May 14, 1993  
LIC-93-0146

SUBJECT: Request for Additional Information Concerning the Fort Calhoun Station Spent Fuel Pool Rerack (TAC No. M85116)

OPPD Responses to April 8, 1993  
NRC Questions on the FCS Spent Fuel Pool Rerack

Fig. 1

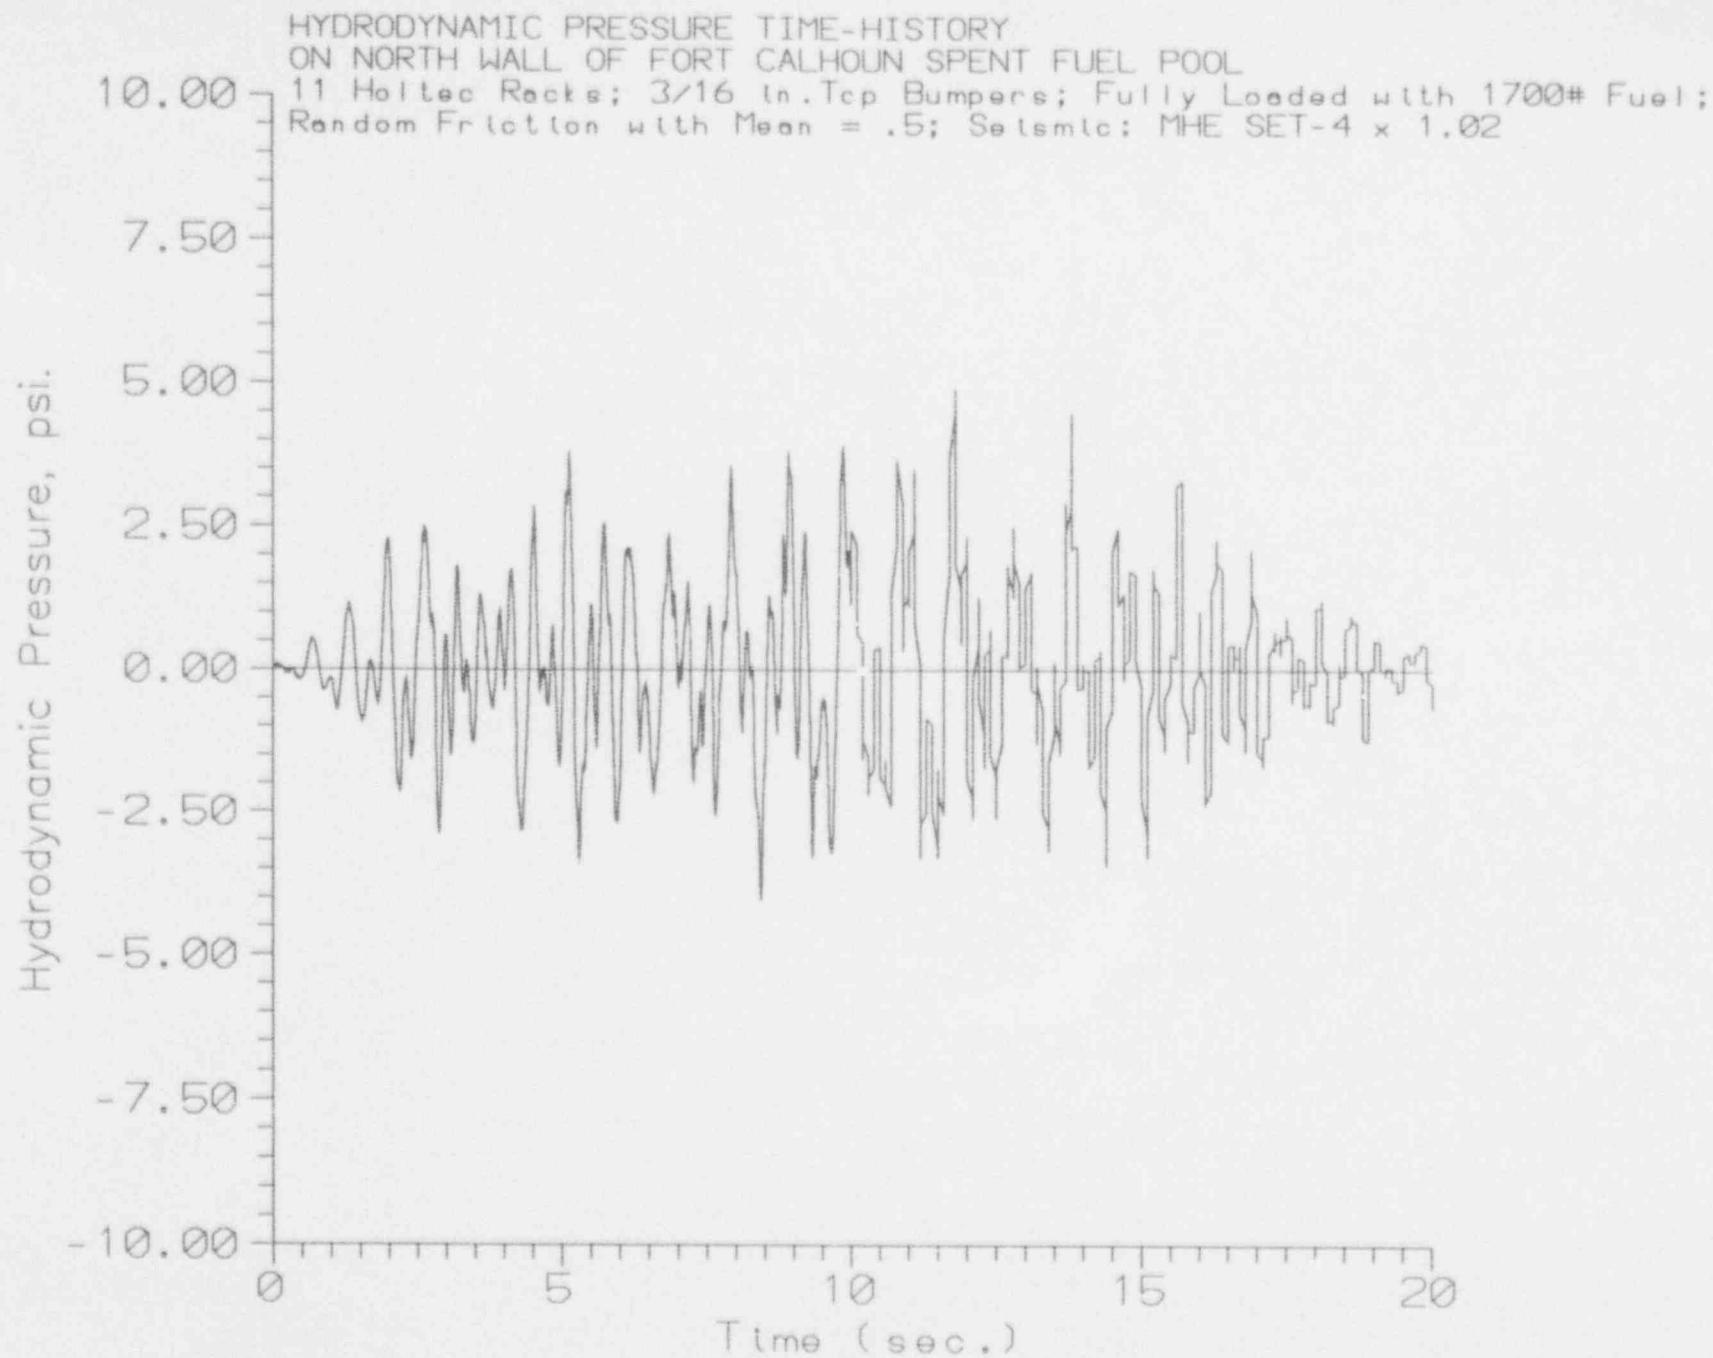
Provide the details of the findings of Run I.D. DRA1MHEO.RF8 for the fuel assembly impacts against the cell wall:

- a) The magnitude of the largest impact force and location of the impact in the fuel assembly and cell wall.
- b) The masses and accelerations of the fuel assembly and the cell wall at that critical point,
- c) The effects of the fluid between the fuel assembly and cell wall during the interactions, and
- d) Provide experimental study that verifies the numerical simulation of the fuel assembly and wall interactions.

The rattling effect of the fuel assemblies inside the storage cells is modeled by five lumped masses at five equally-spaced elevations. The maximum rattling forces at the five locations and the instants of time when the maxima are reached are provided in Table 1. Note that mass number 2 (Figure 1) shows the largest value of the impact force.

The magnitude of the lumped masses is also provided in Table 1. The total weight of a fuel assembly is 1380 lbs.
